PWR Small Break LOCA Evaluation Model, S-RELAP5 Based

EMF-2328(NP)(A)
Revision 0
Supplement 1(NP)(A)
Revision 0

**SUBJECT: FINAL SAFETY EVALUATION BY THE OFFICE OF NUCLEAR REACTOR
REGULATION FOR TOPICAL REPORT EMF-2328(P)(A), REVISION 0,
SUPPLEMENT 1, REVISION 0, "PWR [PRESSURIZED WATER REACTOR]
SMALL BREAK LOCA [LOSS-OF-COOLANT ACCIDENT] EVALUATION MODEL,
S-RELAP5 BASED" (TAC NO. ME8227)**

TOPICAL REPORT EMF-2328(P)(A), REVISION 0, SUPPLEMENT 1, REVISION 0

Figure 4-13: PCT Comparison Base Case/1B_2B_Clearing
Case/2B_Clearing Case

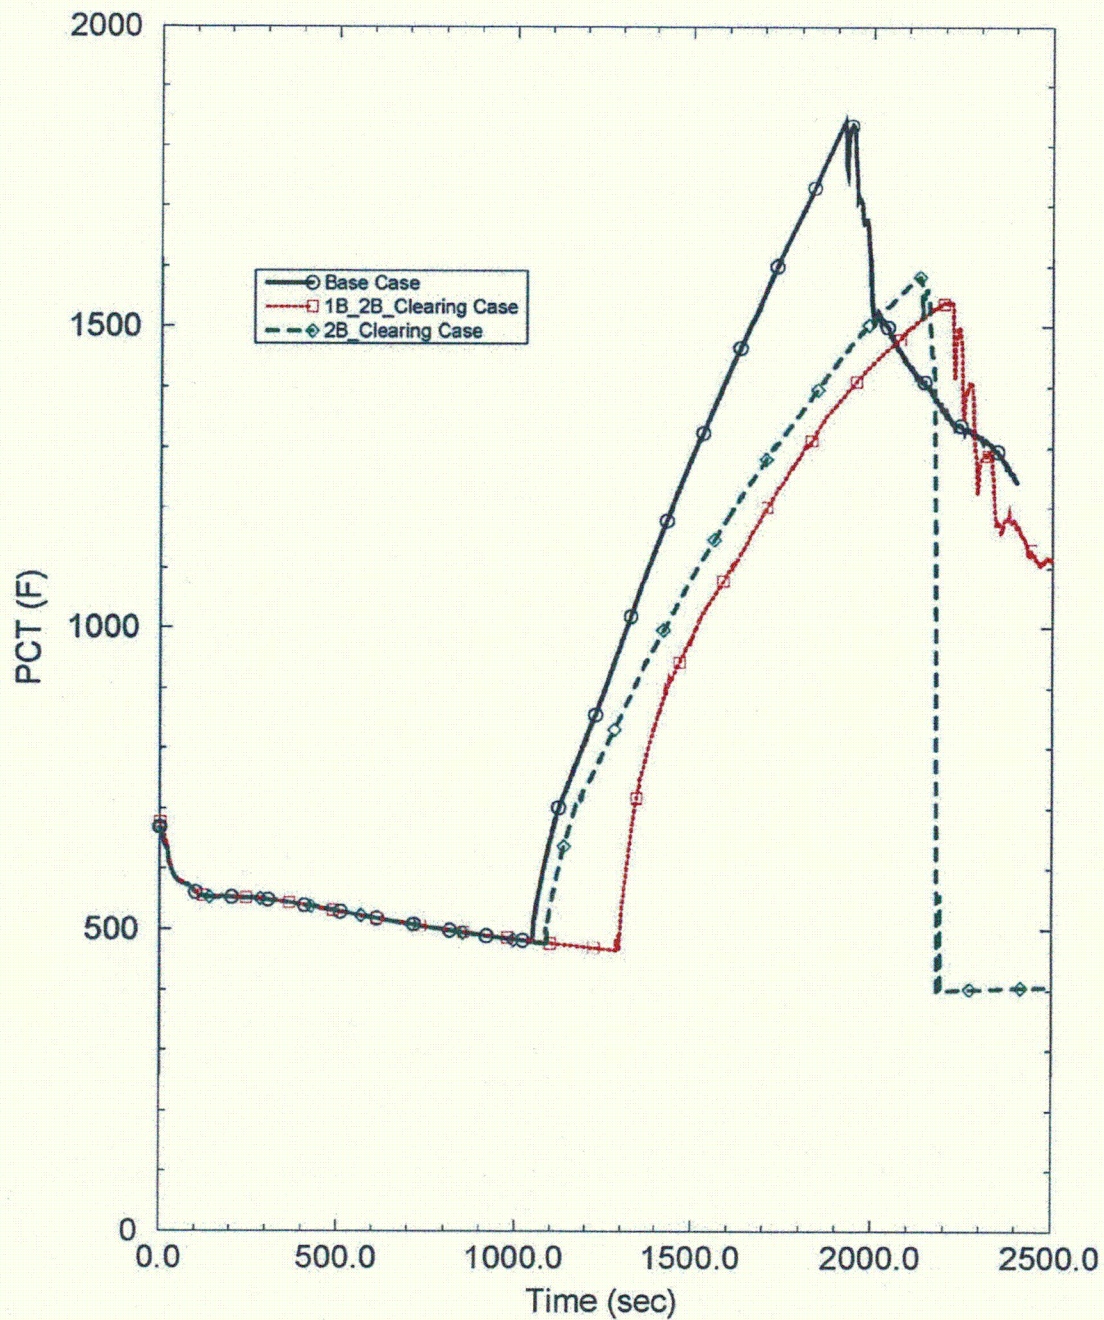
Figure 4-13 shows the PCT for the three analyses performed. The *Base Case* predicts the highest PCT due to the larger downcomer liquid entrainment. The different core heatup behavior between the *1B_2B_Clearing Case* and the *2B_Clearing Case* follows the behavior of core collapsed liquid level described above with the result that the PCT is slightly lower for the *1B_2B* case.

The analyses discussed in this response show that when the broken leg clears then the effects of downcomer liquid entrainment, vapor flow resistance and draining of coolant from the upper plenum counter balance each other and the total effect on PCT for the break size analyzed is minimal when multiple/single-loop seal clearing cases are considered. Overall, an increase of 40°F was predicted for the single-loop seal clearing case PCT when compared to the multiple-loop seal clearing case PCT as shown in Table 4-1 and shown in Figure 4-13.
